Stow Parish Council submission concerning the application by Cottam Solar Project Ltd for a Development Consent Order

This submission provides the views of Stow Parish Council (SPC hereafter) on the application by Cottam Solar Project Ltd for a Development Consent Order for the Cottam Solar Panel farm.

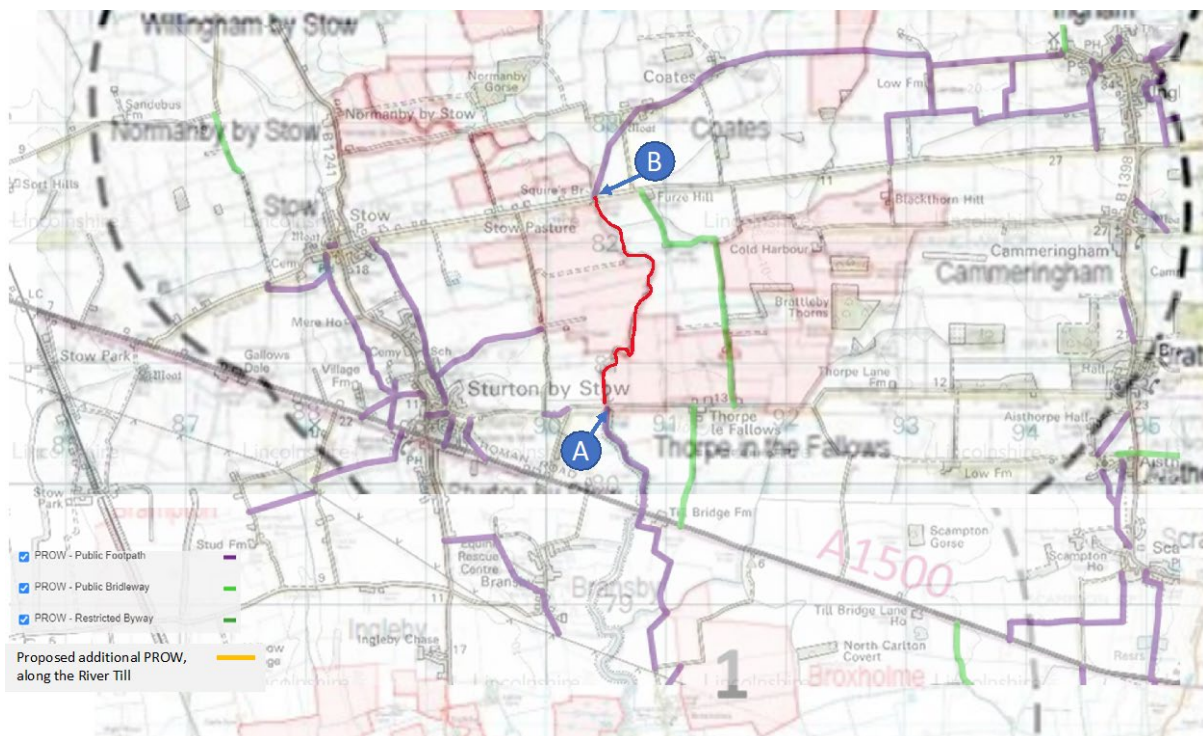
Sturton by Stow and Stow Parish Councils have, independently, asked for a permissive path to be created which would run between Thorpe Bridge (Western side ideally) along the ridge of the River Till riverbank over the Bridge on Ingham Lane (Squires Bridge) to the northern end of Green Lane thence to its intersection with the B1241. See map below, points A and B respectively. We discussed this in the February 2022 meeting with Lanpro and Lizlake and pointed out that as the banks of the River Till are elevated by flood defences, they provide a raised platform on which to walk, and would thus enable observation of both the wildlife of the Till and to see over the panels to the views beyond. This should be achievable but has not been addressed by the developer. We have been informed that this is due to objections by the landowner who Lanpro say maintains that “opening up of any further access along the river corridor would not be compatible with the current farming operation”. Whilst we view that with considerable scepticism, the Applicant has told us that the landowner’s objection means that they cannot pursue this linking of walking routes.

With reference to the following map, we believe that the section of our request for access for walkers between points A (the bridge on Thorpe Lane over the Till) and B (Squires Bridge on Ingham Road) is still worth including as an amenity to residents as it would link two existing PROWs. This would materially improve access to the Countryside.
